**GOVERNMENT OF THE DISTRICT OF COLUMBIA**  
**DEPARTMENT OF TRANSPORTATION**

**MEMORANDUM**

**DATE:** May 7, 2012

**SUBJECT:** **Chevy Chase Circle Signalization at Western Avenue Approaches**

**Figure 2: Traffic Signal installation for Chevy Chase Circle and Western Avenue, N.W (west)**

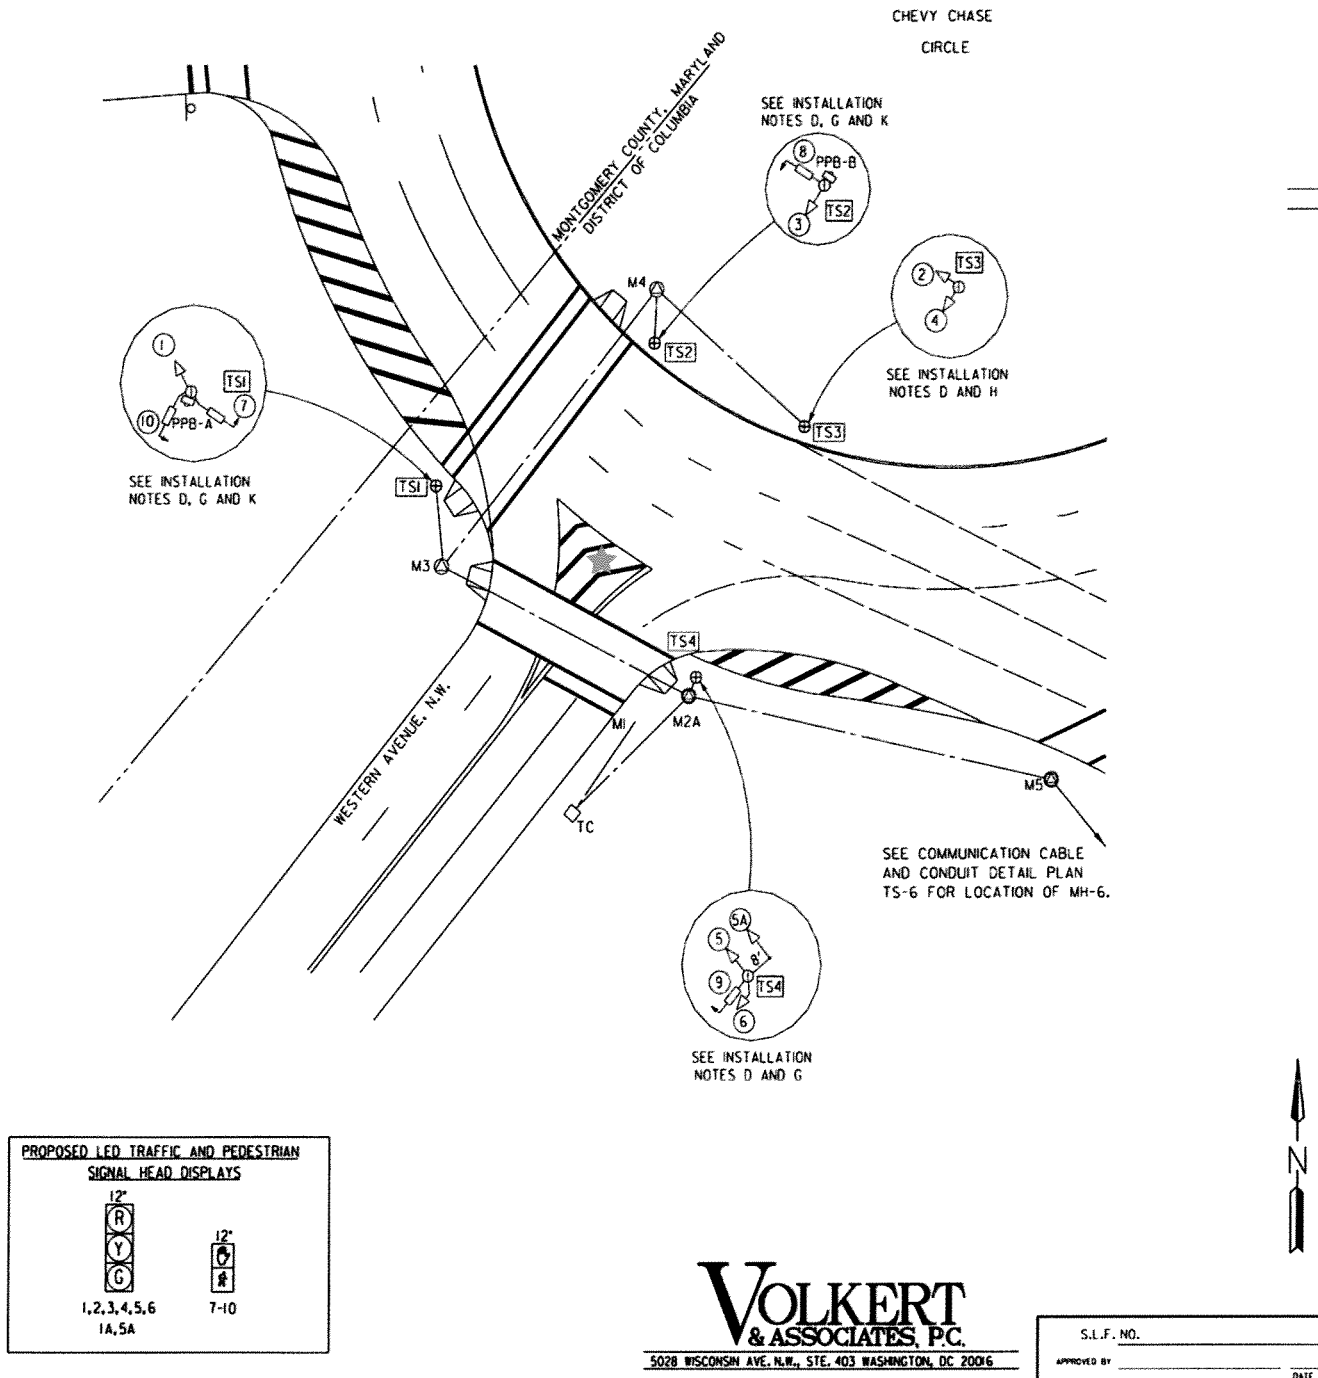
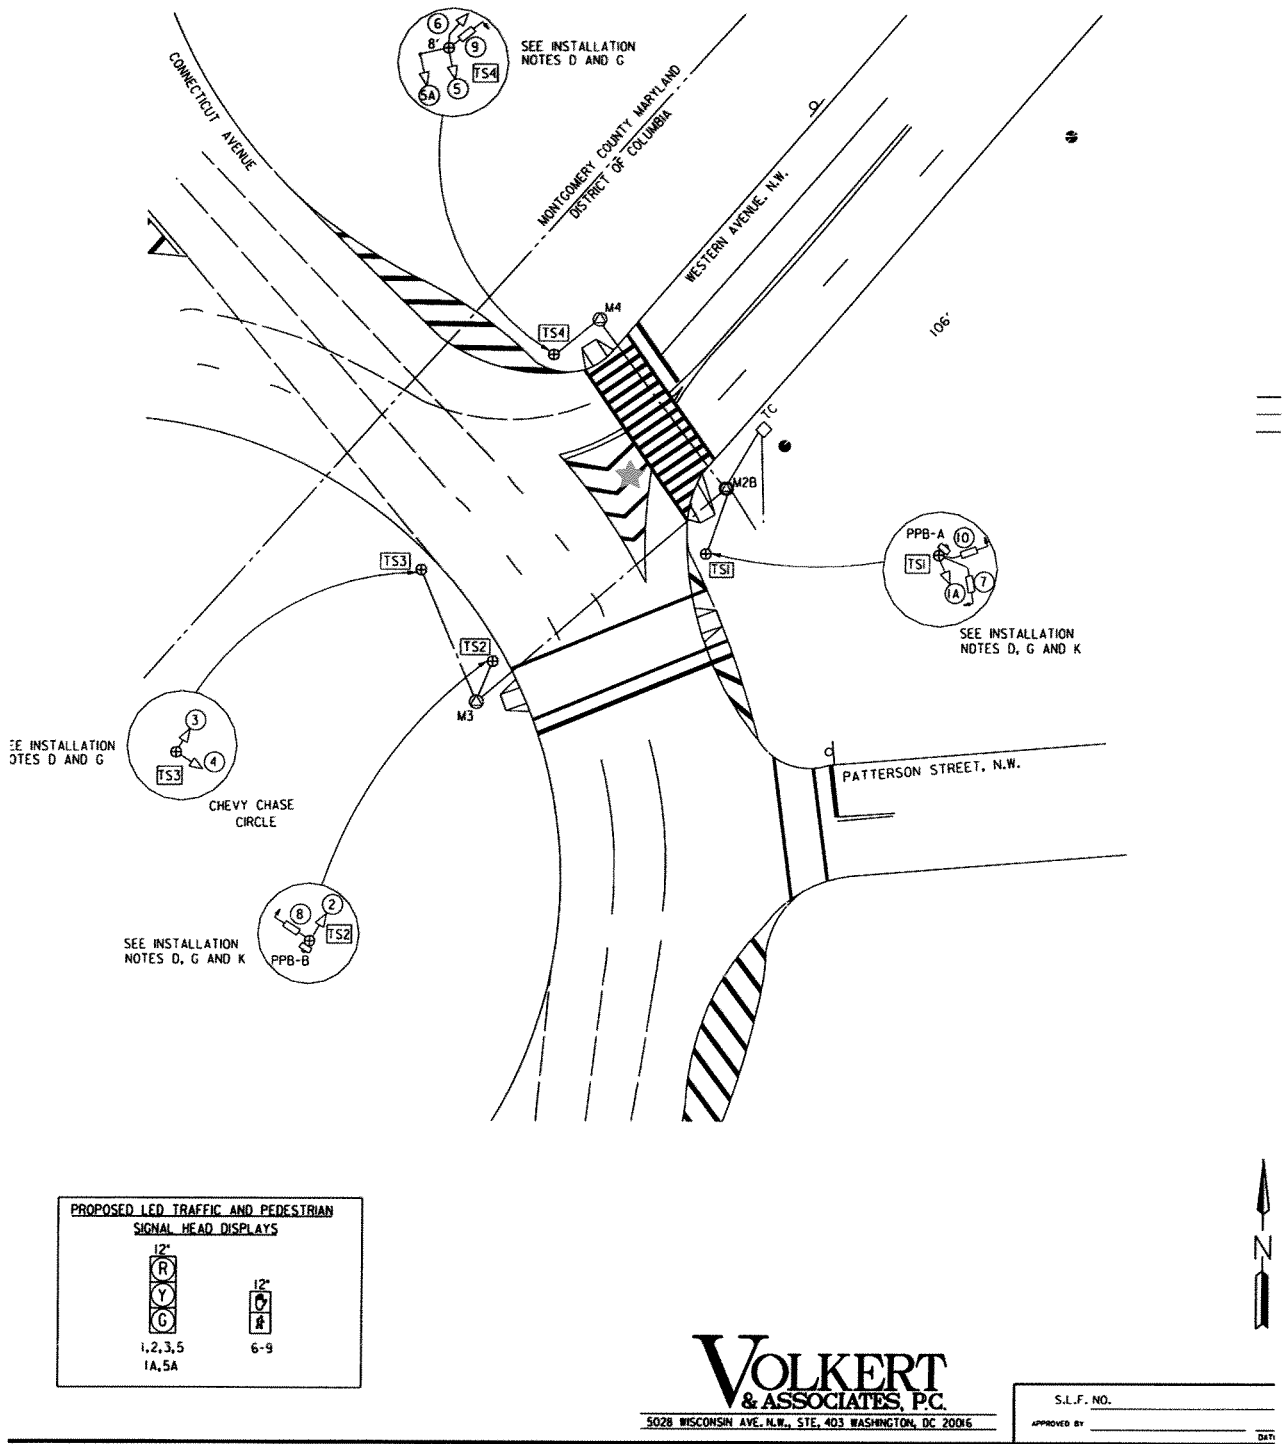
- ***NPS prefers to not have any of the poles installed on NPS property.***

- ***NPS suggests that only one pole will be allowed in the circle.***

- ***The poles as proposed are too close to the root system of the trees surrounding the park. The NPS landscape inventory for that park would have to be reviewed.***

- ***Move poles TS2 and TS3 (on both approaches) to the triangular section of the intersection (see the red star) and use a double mast arm to accommodate the functions of TS2 and TS3.***

In order to satisfy federal traffic control and pedestrian safety standards, the locations of TS2 and TS3 need to be located at the proposed locations within NPS property in order to provide a 20 degree cone of vision for approaching drivers.

Federal guidelines and standards per the MUTCD require two signal heads per approach with a 20 degree cone of vision for approaching drivers .

DDOT will make every effort to avoid impacting the tree root systems and locate the poles appropriately. DDOT's trained arborists will inspect the trees and ensure that the project does not adversely impact the tree root system.

There are several reasons the approach is not feasible and would result in major changes to the project:

- ***Safety implications:*** In order to accommodate the poles at the location NPS suggests, the stop bar will have to be moved 40-ft back into Western Avenue, which would reduce the line of sight for drivers entering the circle.
- ***Project Approval Process:*** Because of its size, a double mast arm is used on normally used on highways and freeways. DDOT is certain that this proposal would not meet National Capitol Planning Commission (NCPC) and Commission of Fine Arts (CFA) guidelines and approval.

In order to reduce impacts to NPS property, DDOT proposes to move two manholes (M4 on the west approach and M3 on the east approach), which were originally proposed to be inside the circle onto the roadway. This

would decrease the level of disturbance, trenching, and conduit work to a minimum within NPS property. The level of disturbance would be greatly reduced and only the foundation work per signal described above would occur on NPS property.
